2001 Ford Mustang V6-3.8L VIN 4

## ENGINE OIL PUMP - LIQUID INJECTION SEAL SERVICE

00-26-6

ENGINE 3.8L - OIL PUMP LIQUID INJECTION SEAL  
(LIS) GASKET SERVICE PROCEDURE - MUSTANG  
VEHICLES EQUIPPED WITH 3.8L ENGINE -  
PRODUCED 11/27/2000 THROUGH 5/30/2001 -  
SERVICE TIPS

Figure 1

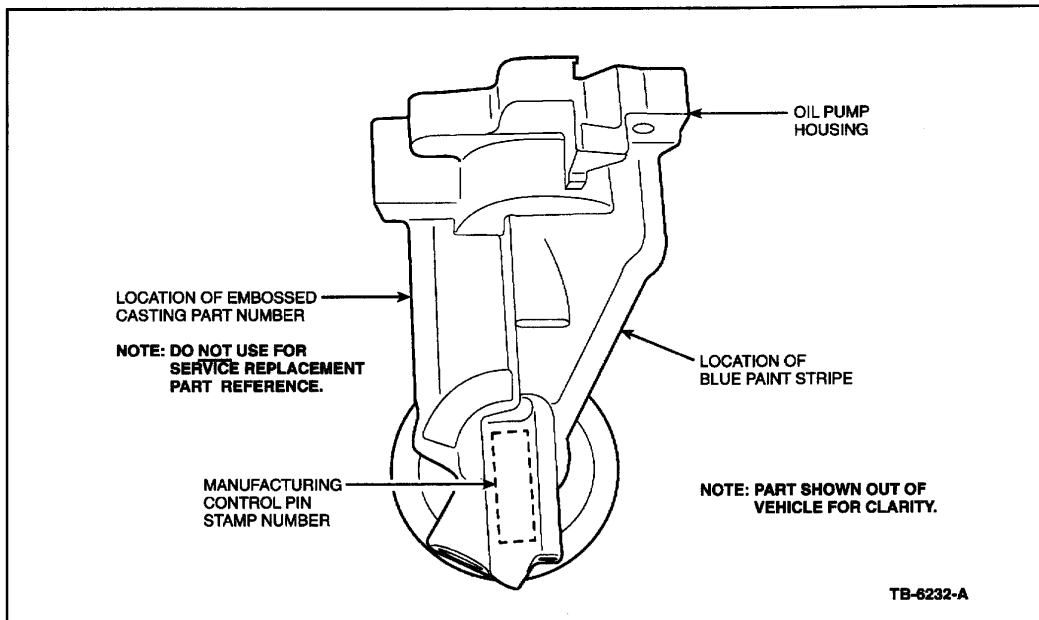
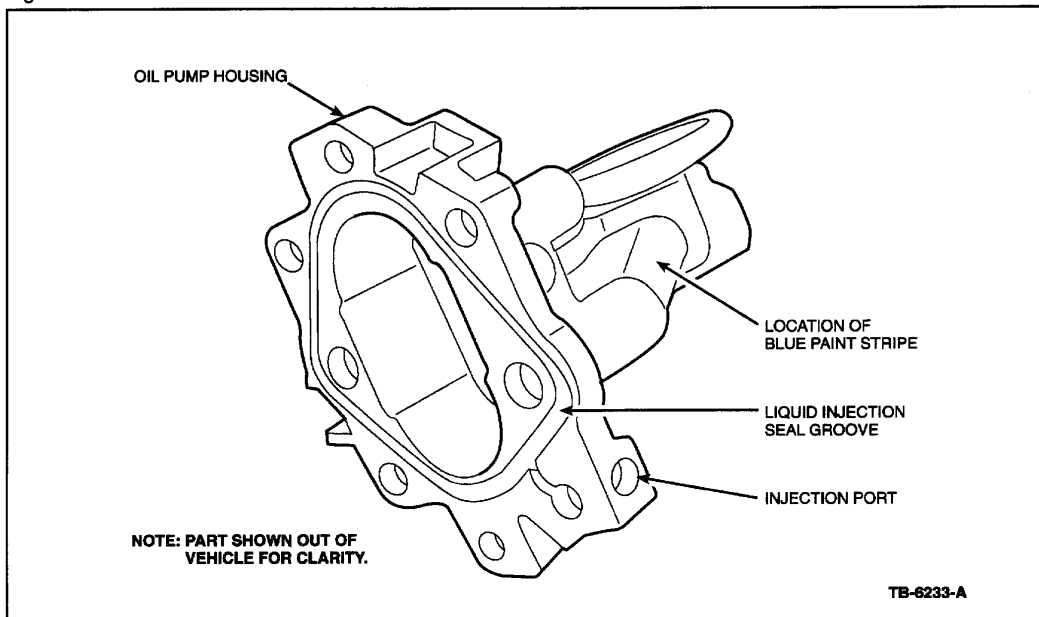
The new LIS oil pumps are identified with a blue paint stripe along the right edge (as viewed from above), a casting part number embossed on the opposite side from the blue paint stripe and a Manufacturing Control stamp number on the pad above the oil filter location (Figures 1 and 2).

1. If the oil pump needs to be serviced for any reason, remove the pump as outlined in the 2000 Mustang Workshop Manual.
2. Identify if it is a new LIS oil pump. If it is, replace the pump with the recommended service oil pump and O-ring seal. Do not attempt to repair the oil pump.
3. Return the LIS oil pump and all of the gasket material that may have adhered to the front cover (scrape off all of the gasket material), place it in a plastic bag, and seal the bag.
